Safety Evaluation Report

for the AUC LLC
Reno Creek ISR Project, Campbell County, Wyoming
Materials License No. SUA-1602

Docket No. 040-09092

U.S. Nuclear Regulatory Commission
Office of Nuclear Materials Safety and Safeguards
Date Issued: September 2016

Figure 2.3-2 Regional Type-Geophysical Log

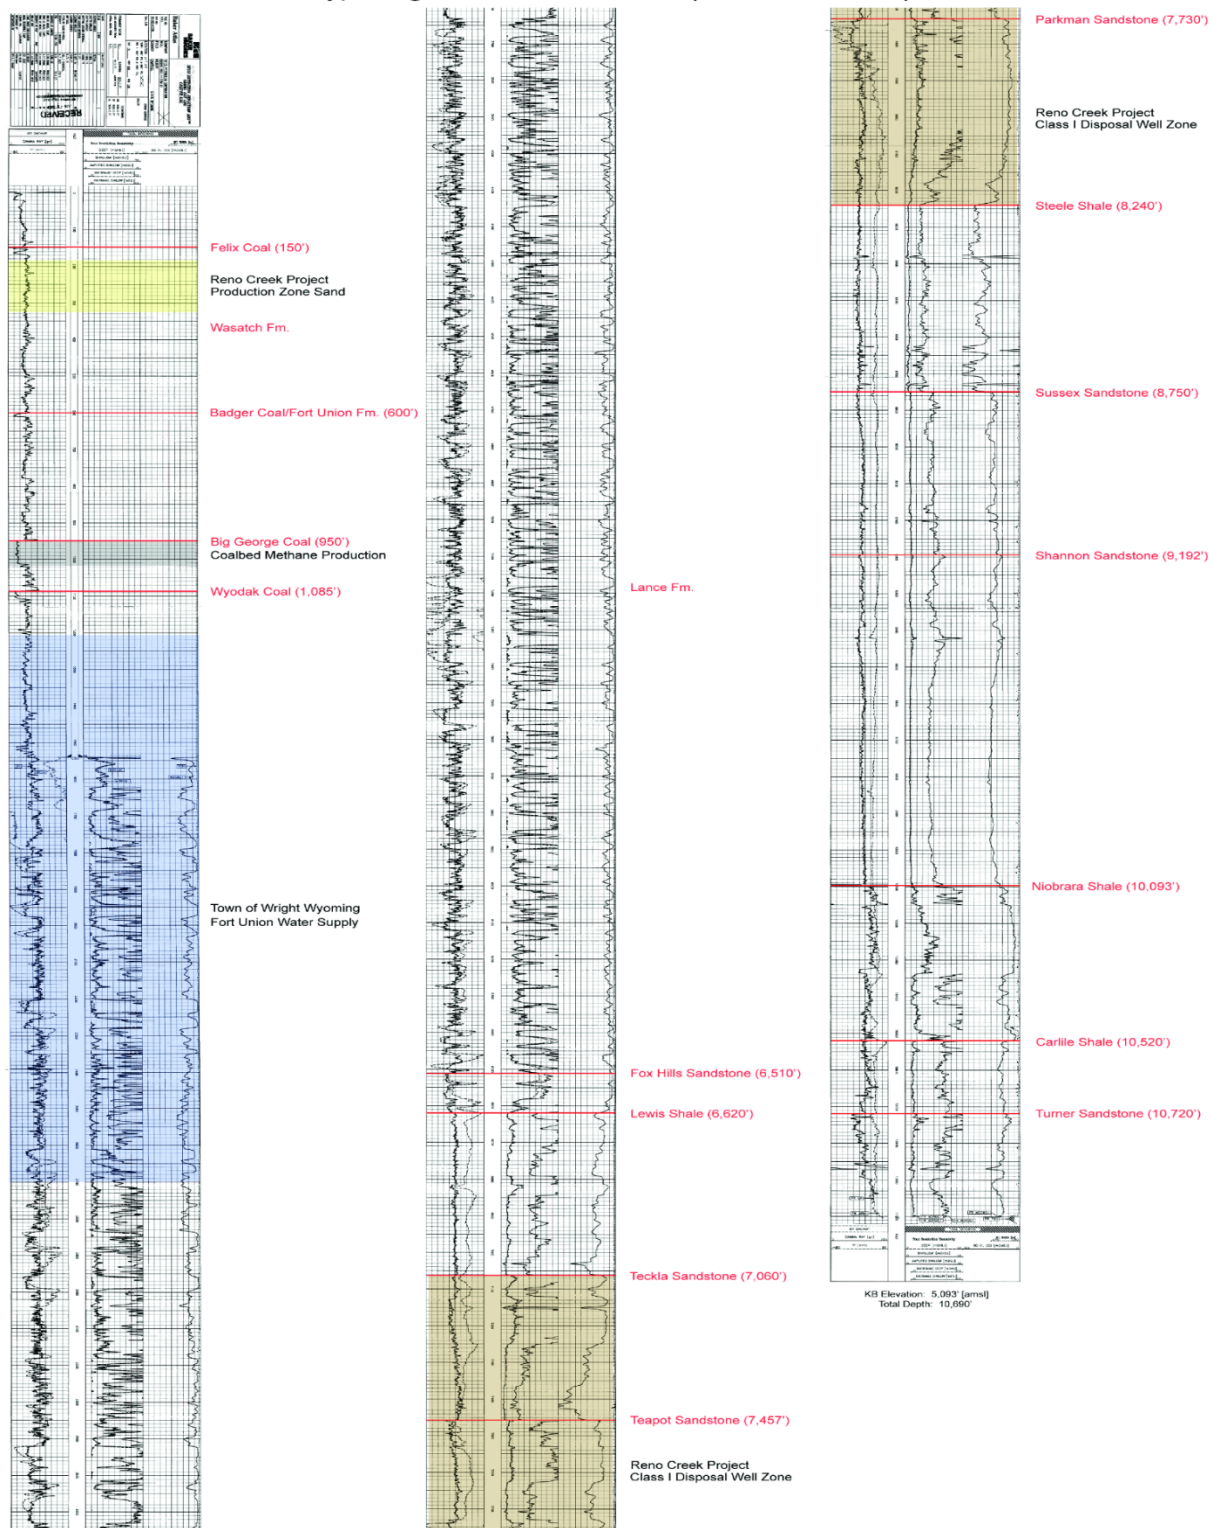
The applicant presents a geophysical log for an oil and gas well located within one-half mile of the Proposed Project as a regional type log (SER Figure 2.3-2). The log depicts the geophysical signature of the subsurface strata to a depth of approximately 3,200 m (10,500 ft). The applicant superimposed on that log locations of various geological formations, as well as the horizons significant to the Proposed Project. These horizons include the Felix Coal (in the upper confining unit), the production zone, the Badger Coal (top of the Fort Union Formation and production zone for the nearby CBM wells), the Wyodak Coal, the zone for the Town of Wright Fort Union Water Supply Wells, and the planned injection zone for the Proposed Project Class I injection wells (SER Figure 2.3-2).

Underlying the Wasatch Formation is the Fort Union Formation. The contact between the Fort Union and Wasatch Formations is the Badger Coal (SER Figure 2.3-2). The Badger Coal is equivalent to the Roland Coal mapped elsewhere in the Powder River Basin (AUC, 2012). The Fort Union Formation consists of clay-rich shales and sandstones with some extensive coal beds (AUC, 2012). The notable coal beds in the Fort Union Formation include the Big George Coal and the Wyodak Coal. The Big George Coal is the zone for CBM production in the Proposed Project and immediately surrounding area. The Big George Coal seam is approximately 305 to 335.3 m (1,000 to 1,100 ft) below grade, or approximately 183 m (600 ft) below the base of the Proposed Project production zone (AUC, 2012). In addition to the coal

Figure 2.4-3 Well Location Map

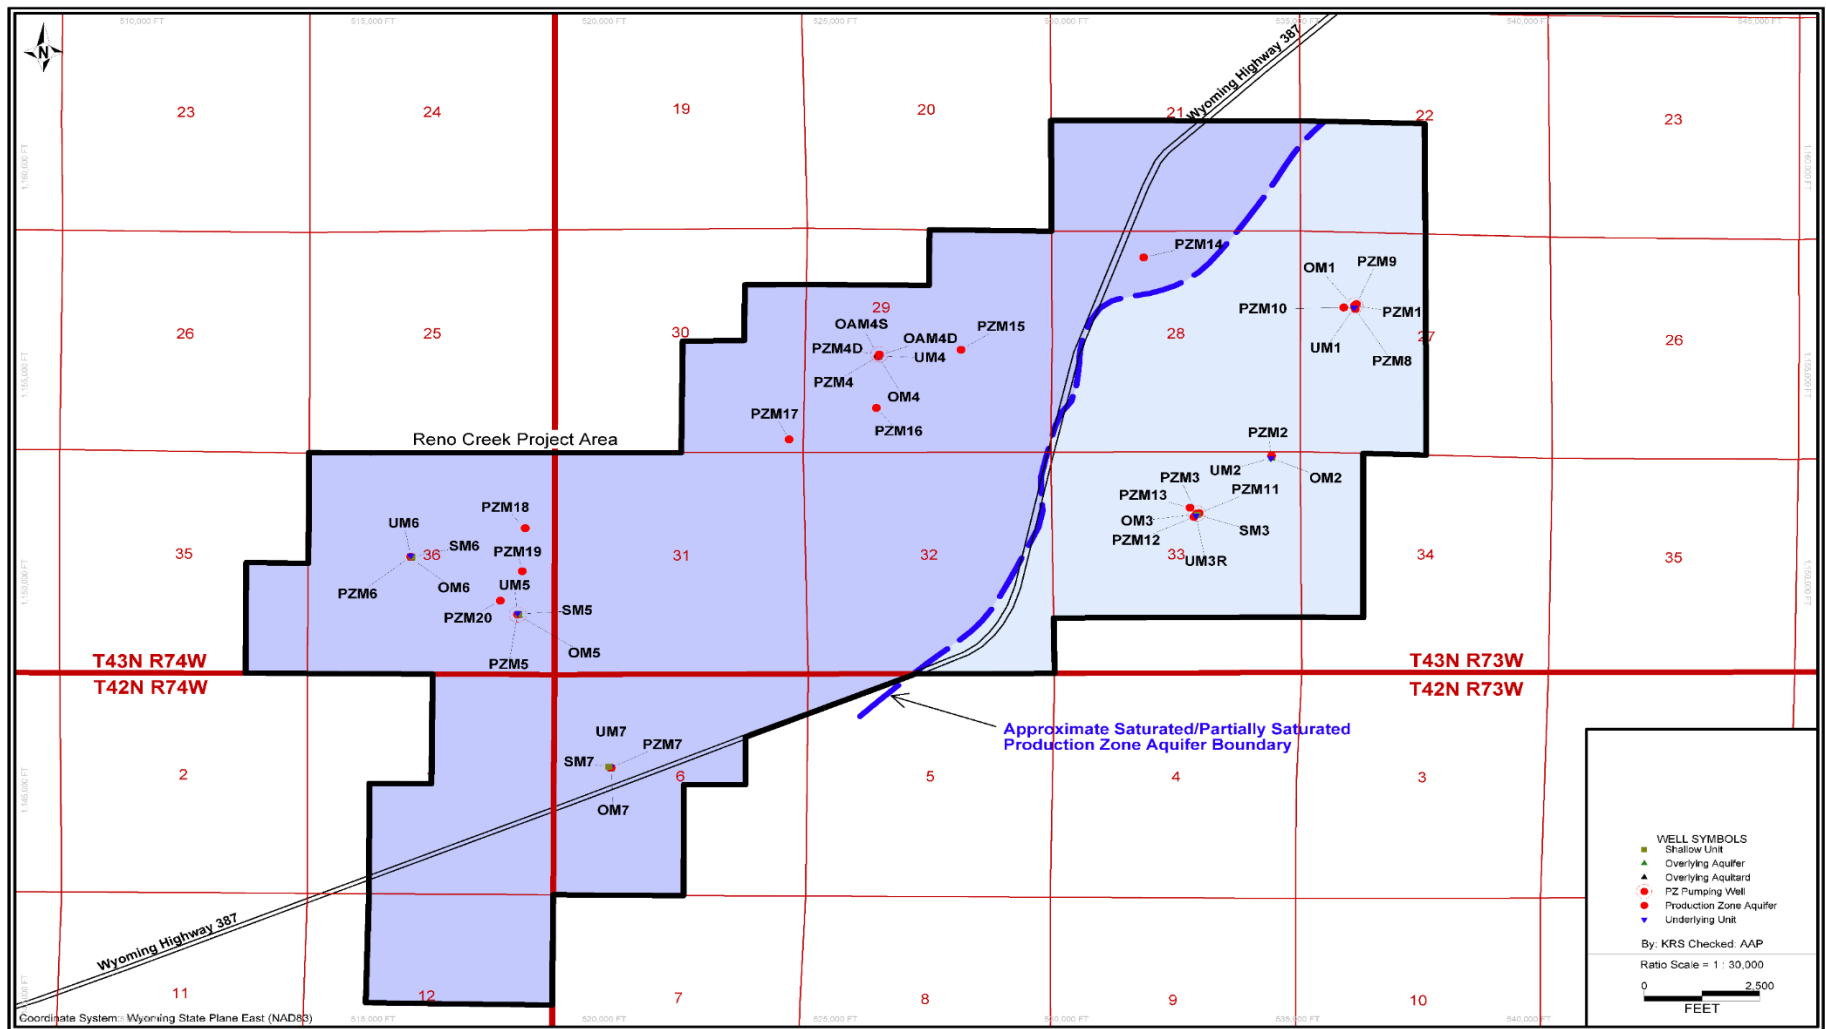
As discussed in more detailed in SER Section 2.3, the applicant divides the subsurface site stratigraphy of the Wasatch Formation significant to the in situ operations into the SM, OM, PZA, and UM hydrostratigraphic units (AUC, 2012). Each unit may be capable of transmitting usable quantities of groundwater and, as such, the applicant installed clusters of four individual wells screened in one of the four subsurface units at seven locations within the Proposed Project area. In addition to the well clusters, the applicant installed two monitoring wells in the Felix Coal (within the overlying aquitard) and 14 wells in the production aquifer (PZA unit). The 14 additional wells include 1 monitoring well in the deeper portion of the production aquifer at a location at which the aquifer is bifurcated by a mudstone Production Zone Monitoring (PZM) 4 (PZM4 well cluster), and 13 monitoring wells in the production aquifer near or adjacent to four of the seven well clusters. The well completion details for the onsite monitoring wells are summarized in SER Table 2.4-1 (see page 2-37). The locations of the monitoring wells are shown in SER Figure 2.4-3.

The applicant reports that water levels in the SM unit reflect perched conditions, and the unit is fully to partially saturated. The water levels in the OM and PZA units reflect partial to fully saturated conditions. For the PZA unit, the applicant depicts an estimated boundary between fully and partially saturated conditions based on the water levels (SER Figure 2.4-3).

Figure 2.4-4 2011 PZA Potentiometric Surface Contour Map

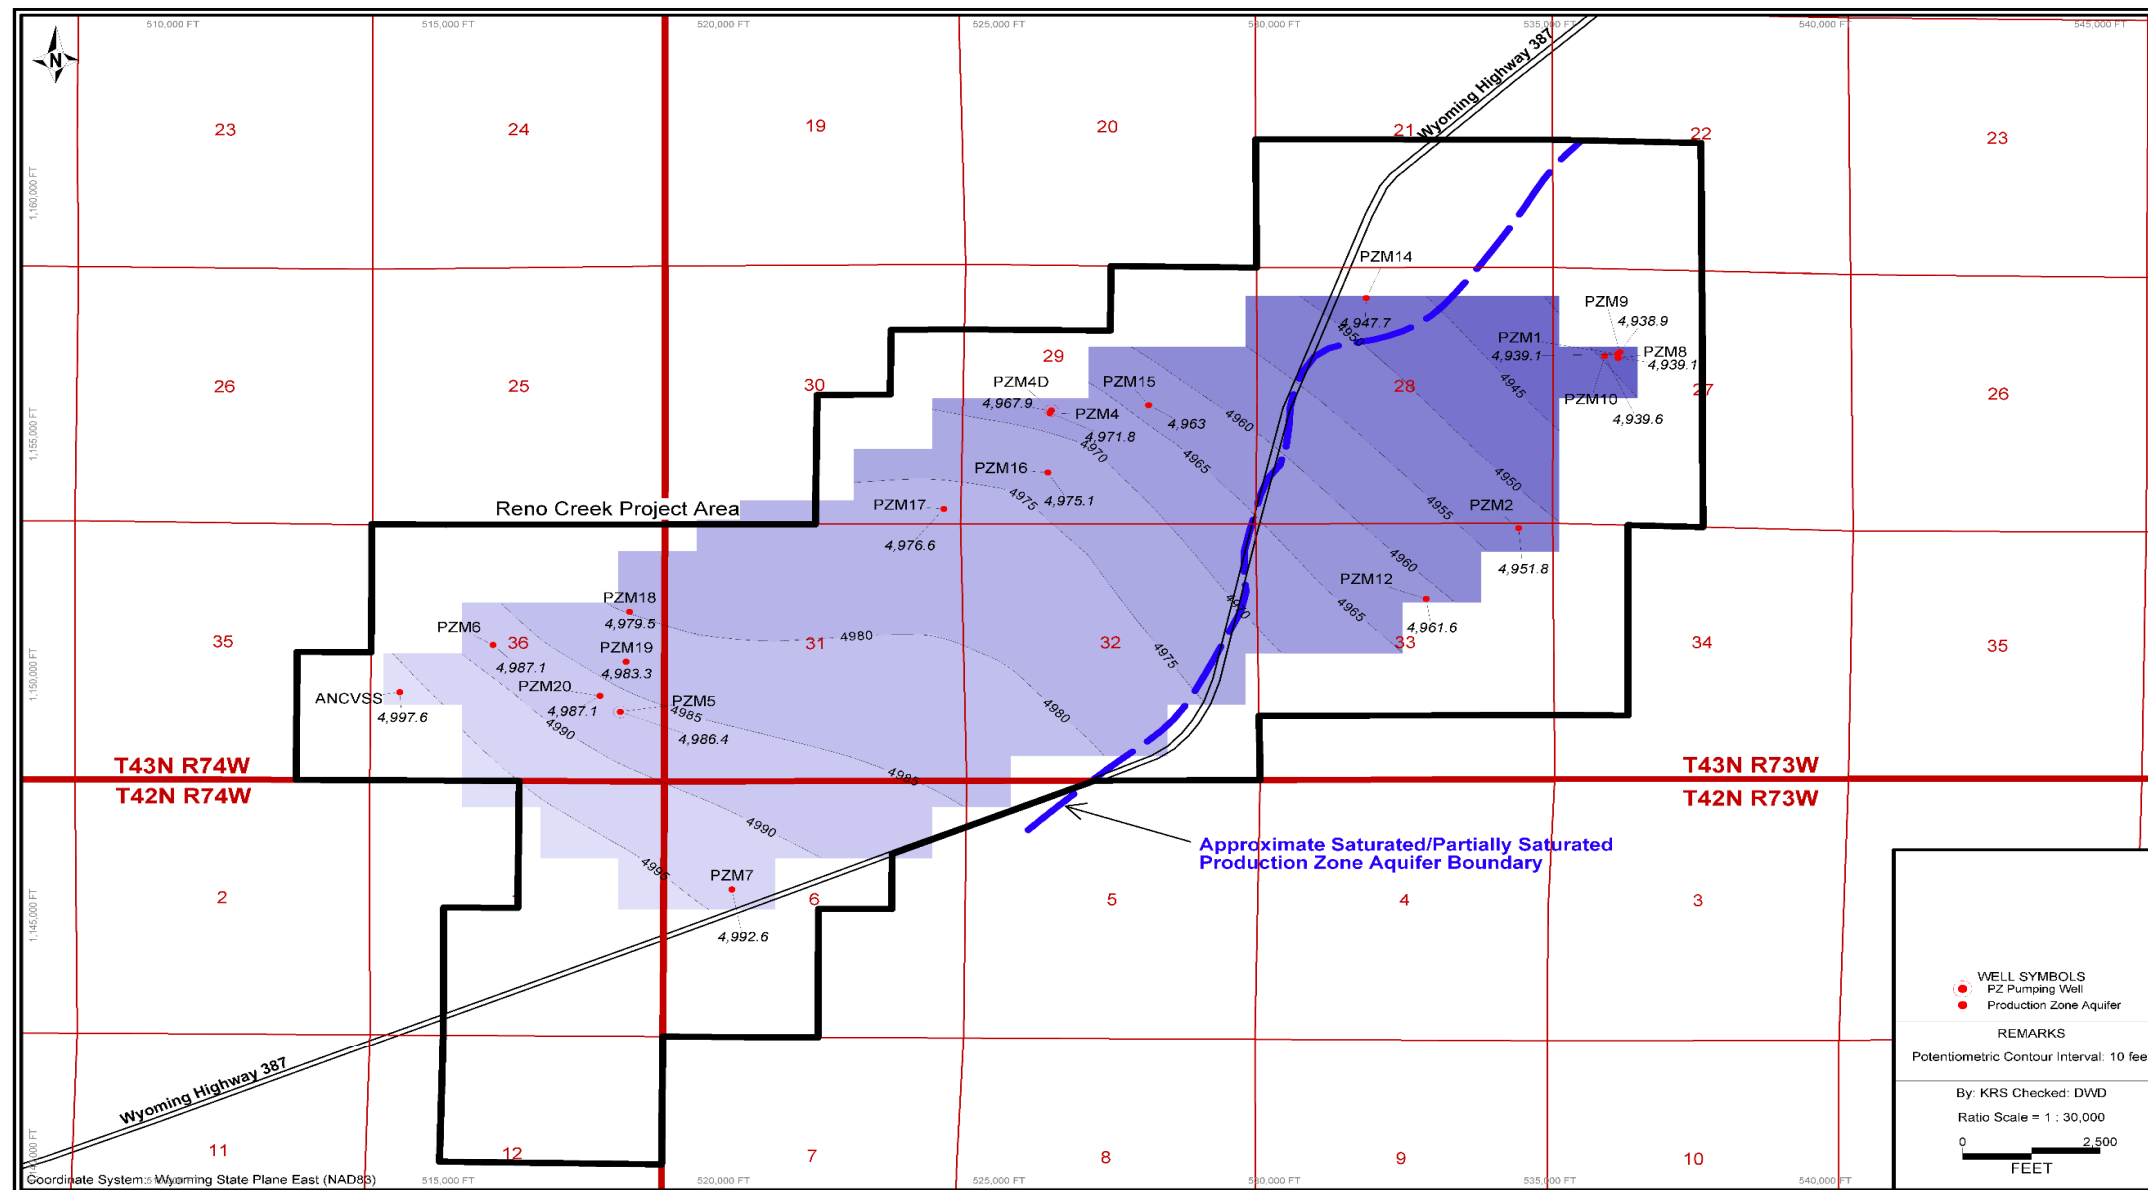
The applicant provided two potentiometric surface contour maps for the PZA (AUC, 2012). The first map is based on water levels measured by the applicant during August 2011 (SER Figure 2.4-4). The potentiometric surface contours depicted on that map indicate northeasterly flow with hydraulic gradients between 0.0017 to 0.0027 ft per foot. The flattening of the gradient is observed in the center of the Proposed Project area, which, the applicant states, is likely related to the presence of thicker and more transmissive sands.

Figure 2.4-5 1993 PZA Potentiometric Surface Contour Map

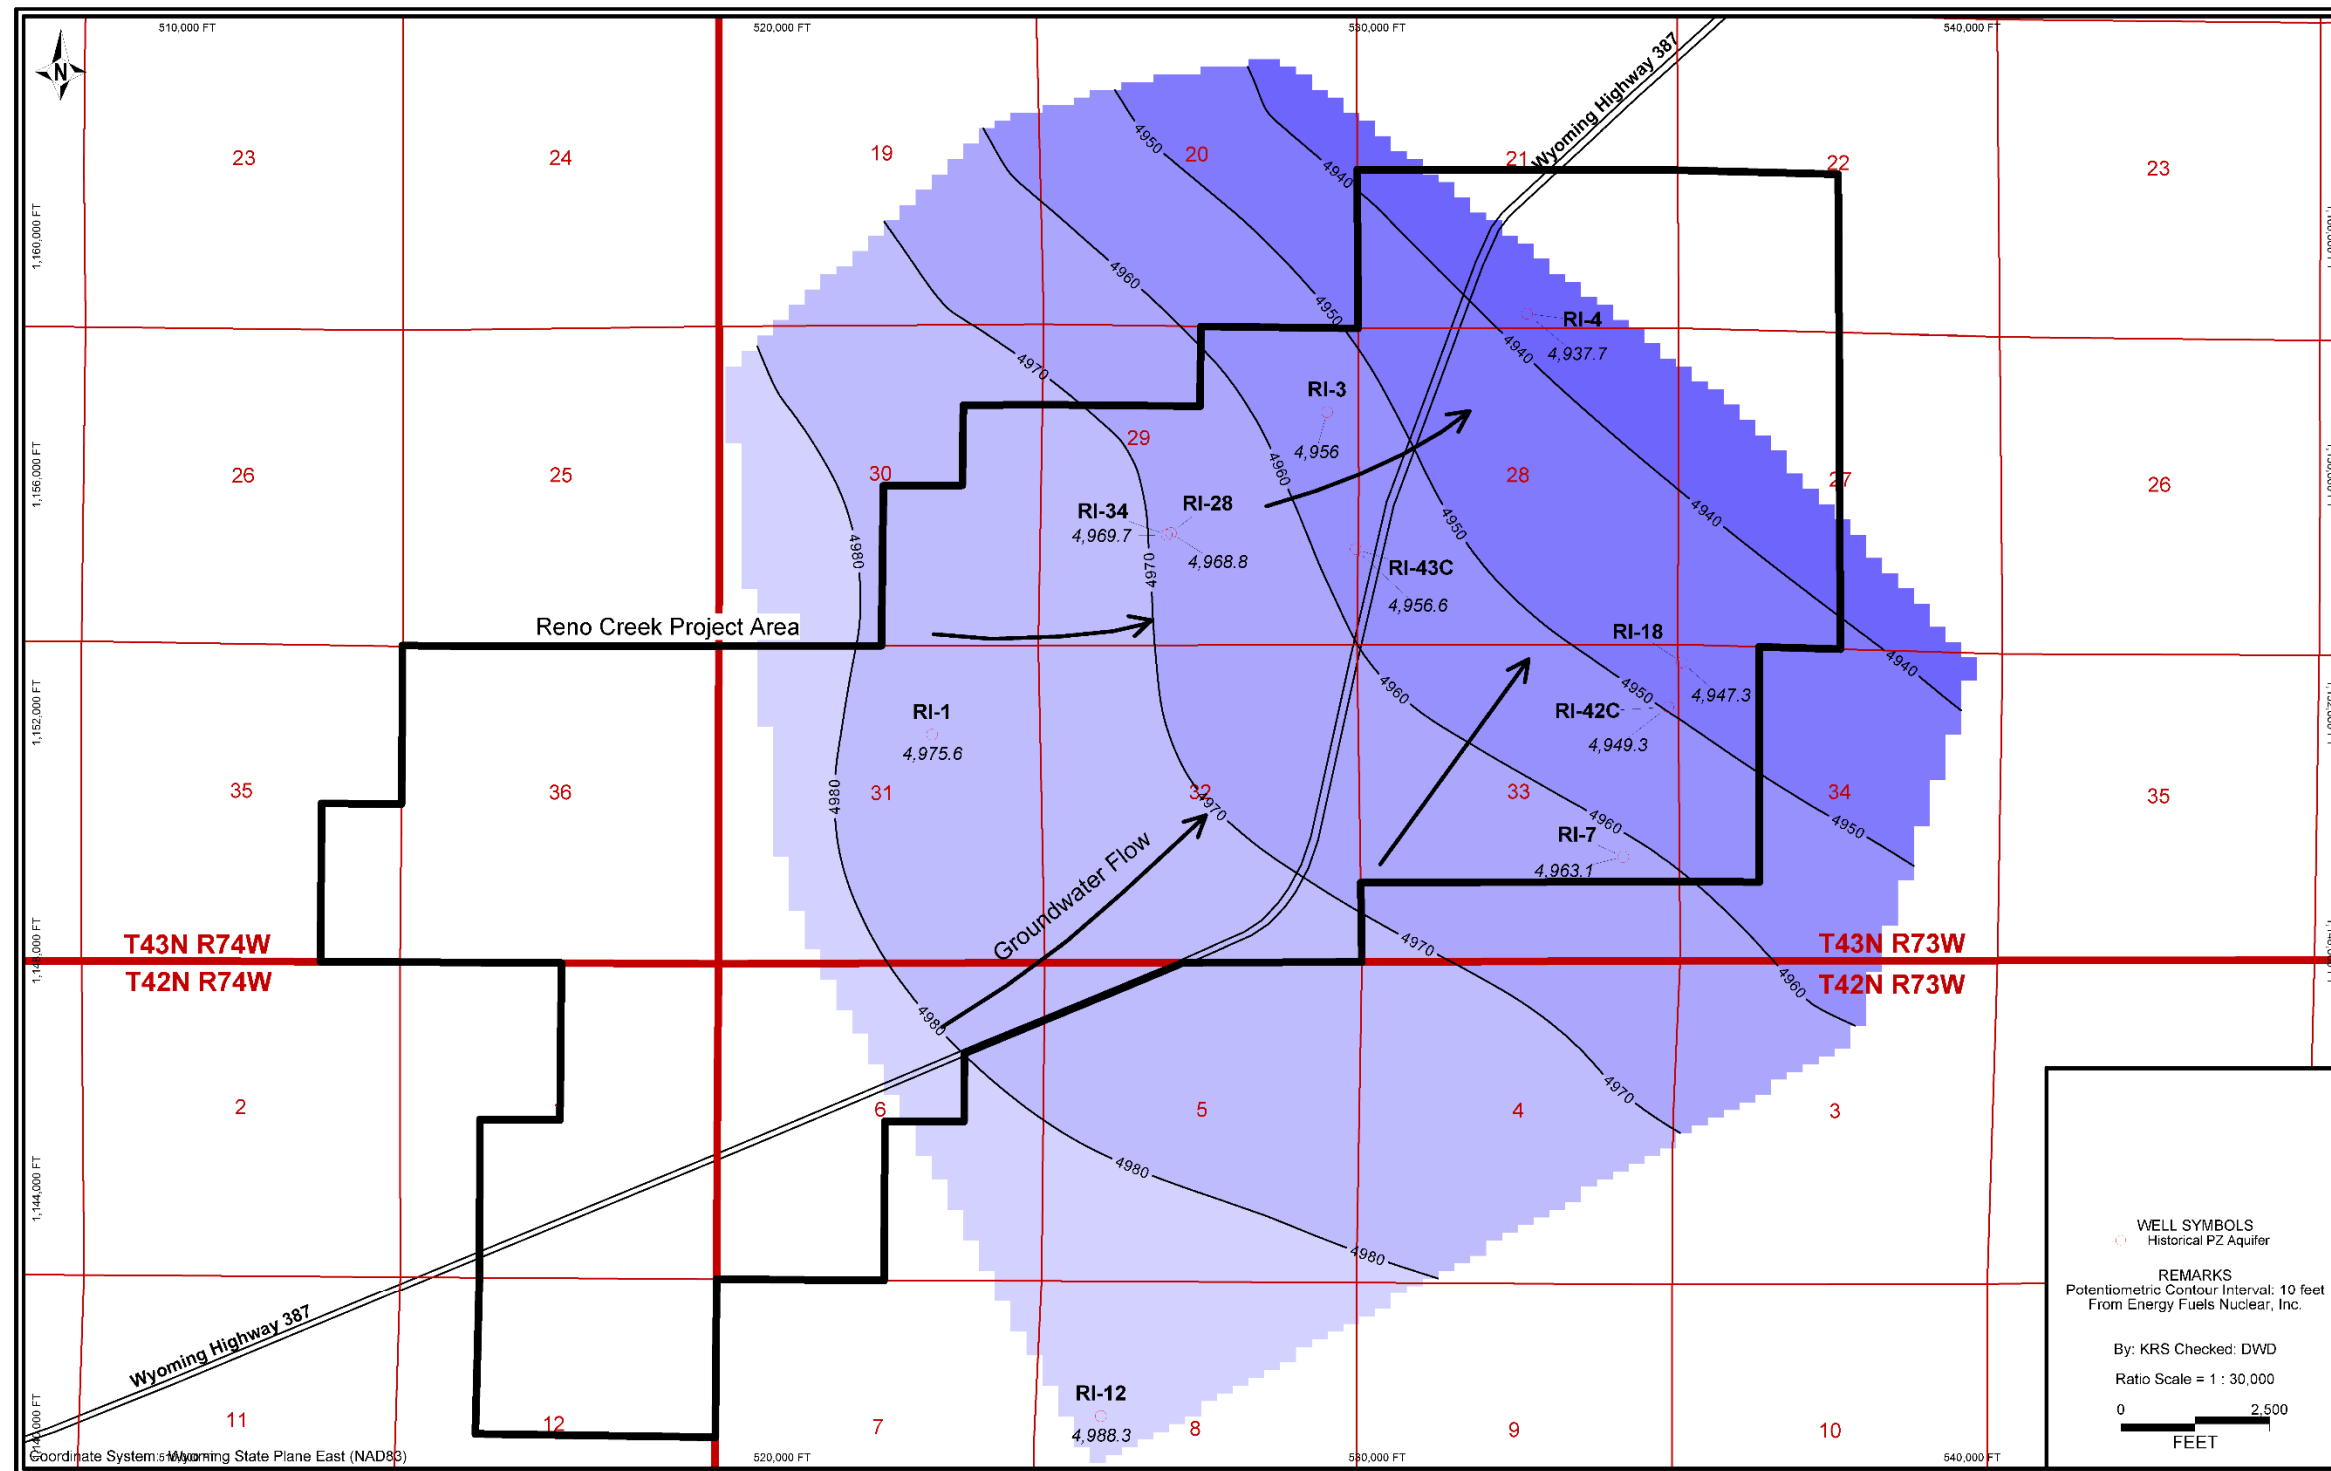
The second potentiometric surface contour map is based on water levels measured by a prior operator in October 1993 (SER Figure 2.4-5). The applicant states that flow directions and hydraulic gradients for the 1993 surface are similar to those based on the August 2011 surface (AUC, 2012).
